Interactive comment on “Sampling frequency trade-offs in the assessment of mean transit times of tropical montane catchment waters under semi-steady-state conditions” by E. Timbe et al.

GENERAL COMMENTS

Fig. 1. Figure 1

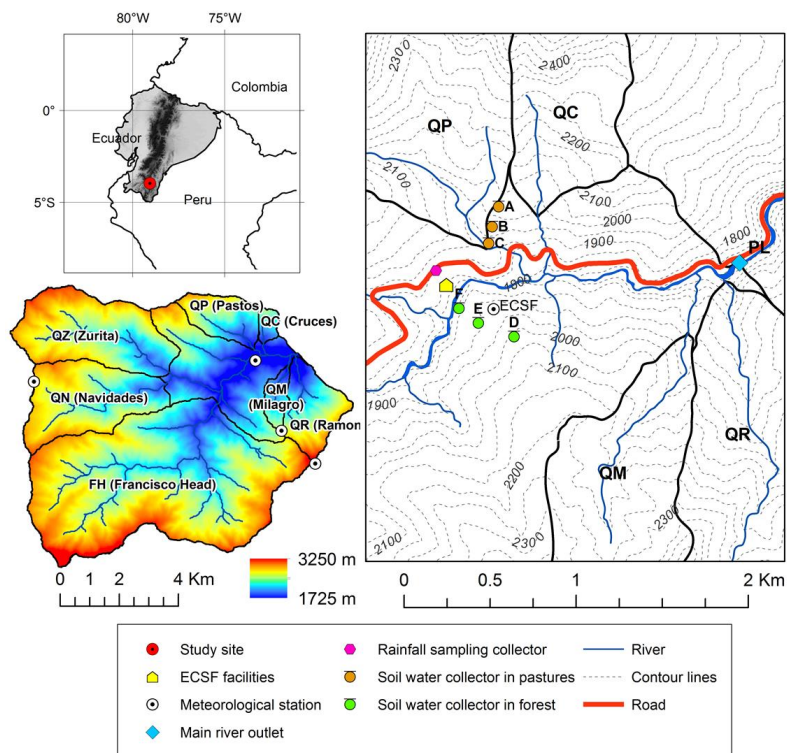
5. Figure 1 with Figure 1: Inevitably the same study site is shown. This is no big deal and only natural to occur. The amount of overlap regarding the rest of the paper however makes this figure problematic, as the Timbe et al. (2014) version shows more detail and could have easily been used in a composite paper.

=> Given that the main objective of the present paper is to account the similarities or discordances between results from diverse sampling frequencies, for this research selected and representative sampling sites were considered when compared to Timbe et al (2014). The site selection was based on the characterization of MTTs and TTDs performed in the previous paper where data of more sampling sites were used. Although Figure 1 in both manuscripts look similar, the previous version of the figure showed more sampling sites which were not considered in the present research and version of Figure 1 (excluded sampling sites were: spring waters SFS, PLS, QRS; micro-catchments TP, Q3, stream water sampling point SF). Similarly, although soil waters were collected at three depths (0.10, 0.25, 0.40 m.) per sampling site (6 sampling sites x 3 depths = 18 sampled waters) as it was described in the former paper, in order to check the resulting trends from diverse sampling frequencies, in the second manuscript we considered that it would be enough to take just the water sample at one depth (0.25 m.) per sampling site. This was justified by the fact that spatial differences between MTT of sampling sites were larger than differences between the water samples at different depths in a given sampling site.

Figure 1 has been redesigned (see attached) to clarify the differences in sampling sites between the previous published manuscript (Timbe et al., 2014) and the current one. Besides, an explanation was included in Subsection 2.2 of the water sites and types analyzed in this paper as compared to previous work:

"Concentrating on the effect of different sampling frequencies on the inferred MTTs, the number of sampled streams was limited to the seven main nested sub-catchments (QN, QP, QC, QM, QR, FH, QZ) and the main catchment outlet (PL) (Fig. 1). Based on the results of Timbe et al. (2014), that differences between soil water sampling sites were bigger than on site differences, we further limited the number of soil depths under consideration from three to one specific soil depth at 0.25 m."

Fig. 2. Figure 2

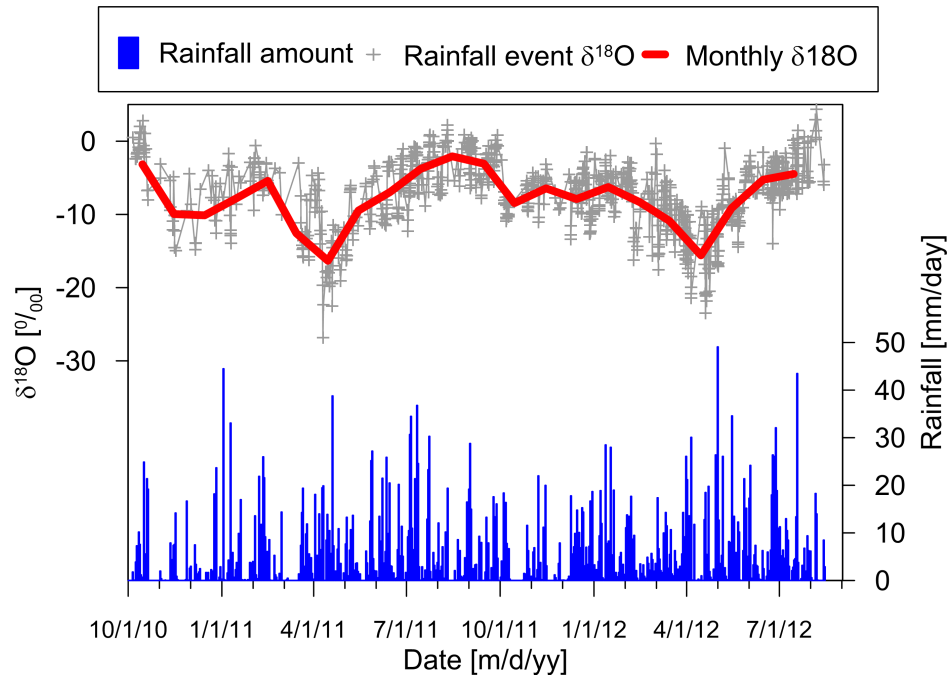
6. Figure 2 with Figure 2: These are almost identical. Striking here is a shift in time series. While the submitted paper is from 9/1/10 to 9/1/12, Timbe et al. (2014) is from 8/1/10 to 8/1/12. This is very confusing and goes hand in hand with discrepancies in both texts about the start of the sampling campaign and discrepancies found in similar tables in both papers. Why is the time series shifted?

7. Figure 3: There is no similar figure in Timbe et al. (2014), but this figure could be removed without drastic loss of information. It is nice to see how the aggregated time series look, but not absolutely necessary to understand this paper.

=> The first 1.5 month (mid-August 2010 until late September 2010) of the sampling campaign used in Timbe et al. (2014) was neglected to homogenize the different time series for the aggregation into different sampling frequencies (up to 3 months during tryouts). The starting period for rainfall data and all other datasets was therefore shifted to the beginning of the last quarter in 2010 (first of October 2010).

To avoid confusion with the similar figure published in the former paper, the Figures 2 and 3 in the current manuscript have been integrated. The redesigned figure (now Figure 2) clearly shows the seasonality of the event and monthly based Oxygen-18 isotopic signals together with daily rainfall. Reference to the former paper has been included in the text. Also the total samples of rainfall and stream water for the present study were checked and corrected.

=> As requested by Referee #2 we deleted Figure 3, and Figure 2 was redesigned such that it shows now a high (event based) and coarse (monthly) time series (see also reply to previous comment).
